Product Change Notice (PCN)

PCN Number: **PCN-0451150R-01**

Product(s) Affected: PJ-037AH

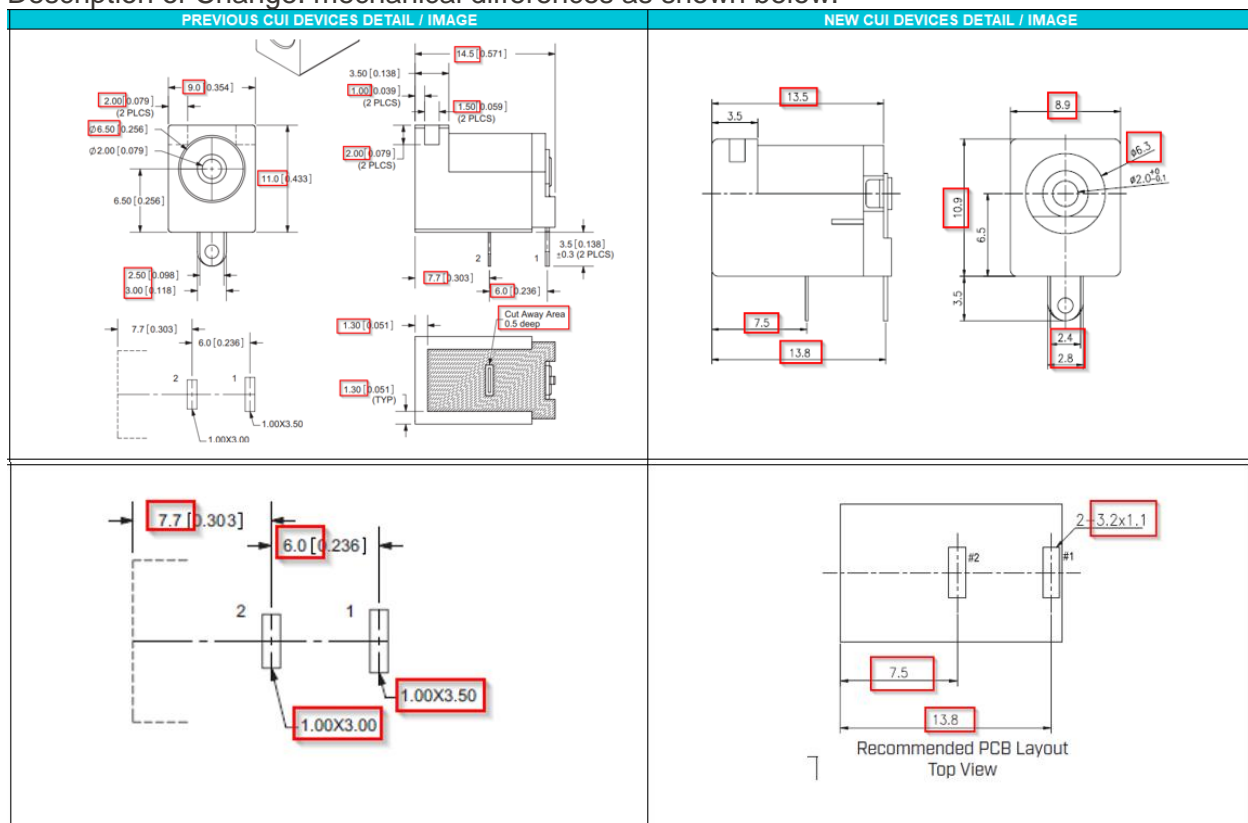
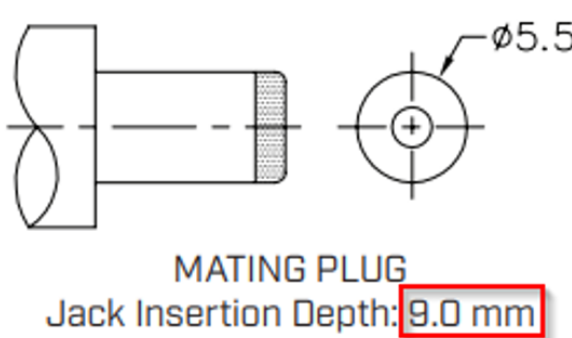
Description of Change: mechanical differences as shown below:

<table border="1" style="width: 100%; border-collapse: collapse;"> <thead> <tr> <th></th> <th>MATERIAL</th> <th>PLATING</th> </tr> </thead> <tbody> <tr> <td>center pin</td> <td>copper</td> <td>nickel</td> </tr> <tr> <td>terminal 1</td> <td>brass</td> <td>silver</td> </tr> <tr> <td>terminal 2</td> <td>copper alloy</td> <td>silver</td> </tr> <tr> <td>plastic</td> <td>PBT</td> <td></td> </tr> </tbody> </table>		MATERIAL	PLATING	center pin	copper	nickel	terminal 1	brass	silver	terminal 2	copper alloy	silver	plastic	PBT		<table border="1" style="width: 100%; border-collapse: collapse;"> <thead> <tr> <th>DESCRIPTION</th> <th>MATERIAL</th> <th>PLATING/COLOR</th> </tr> </thead> <tbody> <tr> <td>center pin</td> <td>copper alloy</td> <td>nickel</td> </tr> <tr> <td>terminal 1</td> <td>brass t=0.3 mm</td> <td>nickel-silver</td> </tr> <tr> <td>terminal 2</td> <td>phosphor bronze t=0.3 mm</td> <td>nickel-silver</td> </tr> <tr> <td>housing</td> <td>PBT (UL94V-0)</td> <td>black</td> </tr> <tr> <td>cover</td> <td>PBT (UL94V-0)</td> <td>black</td> </tr> </tbody> </table>	DESCRIPTION	MATERIAL	PLATING/COLOR	center pin	copper alloy	nickel	terminal 1	brass t=0.3 mm	nickel-silver	terminal 2	phosphor bronze t=0.3 mm	nickel-silver	housing	PBT (UL94V-0)	black	cover	PBT (UL94V-0)	black

MATERIAL	PLATING																																
center pin	copper	nickel																																
terminal 1	brass	silver																																
terminal 2	copper alloy	silver																																
plastic	PBT																																	
DESCRIPTION	MATERIAL	PLATING/COLOR																																
center pin	copper alloy	nickel																																
terminal 1	brass t=0.3 mm	nickel-silver																																
terminal 2	phosphor bronze t=0.3 mm	nickel-silver																																
housing	PBT (UL94V-0)	black																																
cover	PBT (UL94V-0)	black

Insertion/extraction force adjusted to 0.3 ~ 2.0 kg
